BCA & ACCESS ASSESSMENT REPORT

PROJECT: New High School in Jerrabomberra PREPARED FOR: Schools Infrastructure

Revision 3

Reference: 210035

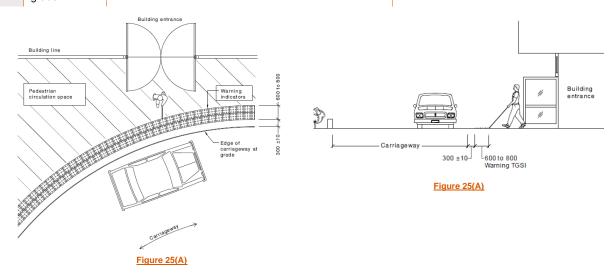
Further Information Required:

Confirmation is to be provided as to whether the bus bays are at the same level than the adjoining pedestrian area.
